Hearing Identifier: TurkeyPoint_COL_Public
Email Number: 379

Subject: Re: Turkey Point reactor application
Sent Date: 6/7/2011 6:24:37 AM
Received Date: 6/7/2011 6:24:46 AM
From: David Enfield

A Unified Sea Level Rise Projection for Southeast Florida

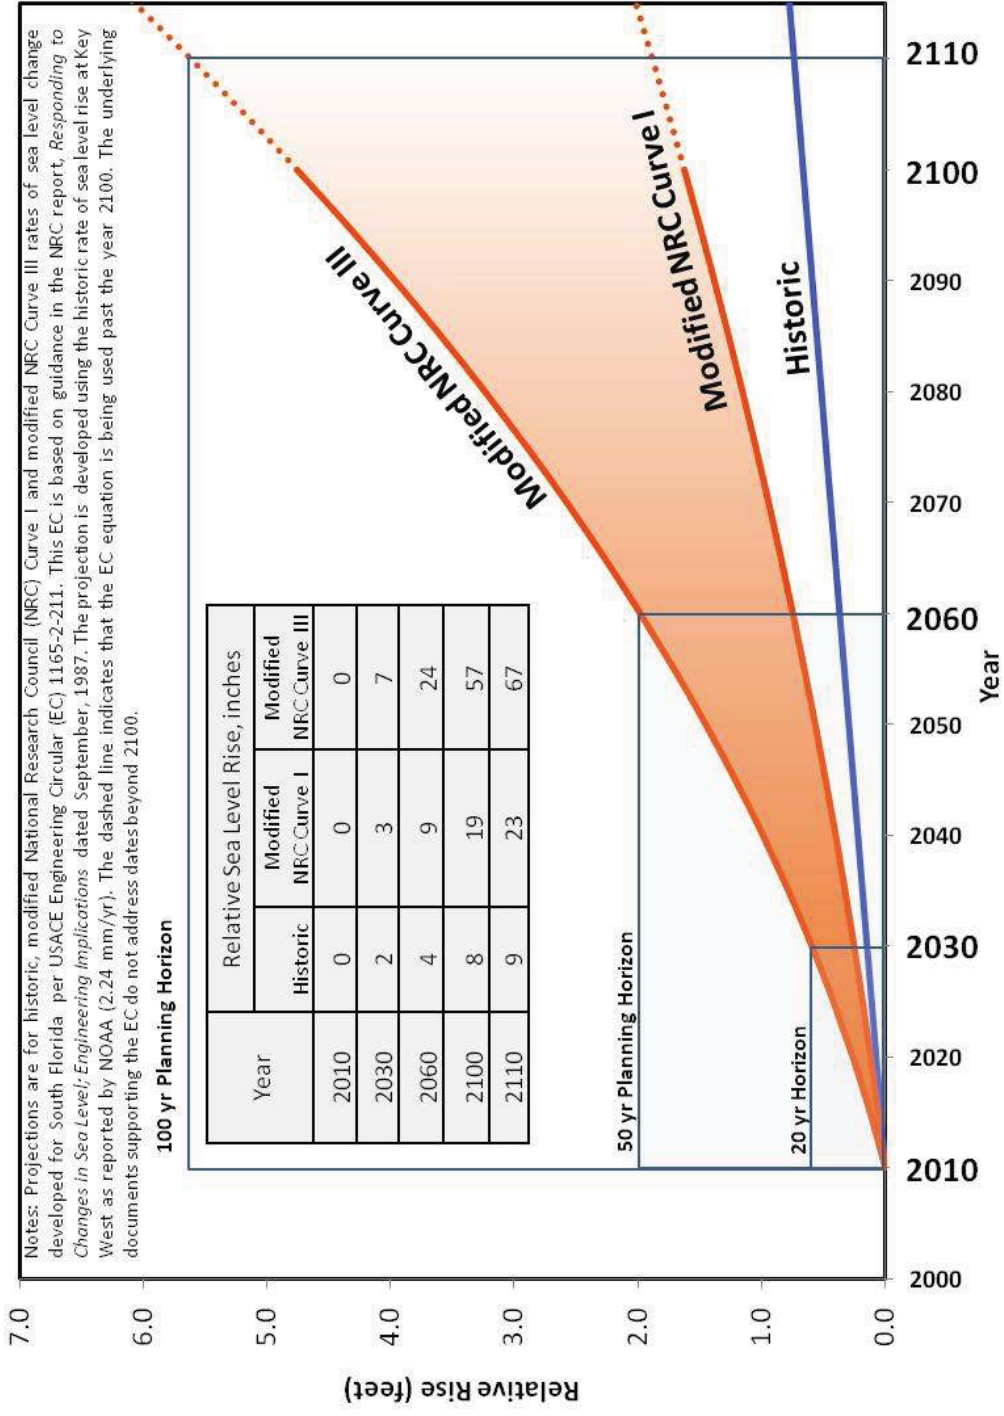
First, a few points about sea level rise (SLR). As I said before, the four SE Florida counties have adopted the projections of the US Army Corps of Engineers, which puts SLR between 2 feet and 6 feet in 100 years. That range pretty much brackets the consensus of climate change science at this time. In one of the NRC messages below it is implied that the maximum SLR by 2100 AD is two feet. I wish to point out that this lower figure is based on the IPCC AR4 report released in 2007, which was based on model results from no later than 2005, and which the IPCC admitted was probably too low because the models were doing a poor job of simulating ice melt. Since then much more research has been done and very few climate scientists now believe the IPCC figures from 2007, including the IPCC themselves. So, I am attaching the SLR report recently finalized by the SE Florida 4-county compact on sea level rise, which is the current basis for planning in the four counties. I refer you to Fig. 3, which I reproduce here:

Please note that a maximum SLR of two feet is projected to occur within the 50 year planning horizon, or about 2060, which is within the lifetime of the proposed reactors, and not at the end of the century as stated earlier by someone. By the end of the century the projected maximum is between 5 and 6 feet. Moreover, please also note that these are not endpoints for SLR and that sea level will continue to rise beyond them in the next century, regardless of mitigation efforts. If fast action were to be adopted by Congress to curb CO2 emissions, SLR could perhaps be limited to the lower end of the range at any given time horizon. But, as I'm sure you are all aware, aggressive mitigation by Congress seems extremely unlikely given the foreseeable political climate, and we are currently on a pessimistic emissions trajectory. Hence, it is only prudent that planning for the reactors be indexed to the highest projected levels. Whatever SLR value you set as possible within the lifetime of the reactors, that amount needs to be subtracted from the design height above current MLW. That adjusted height is the appropriate reference level for discussions of future storm surge (or tsunami) threat.
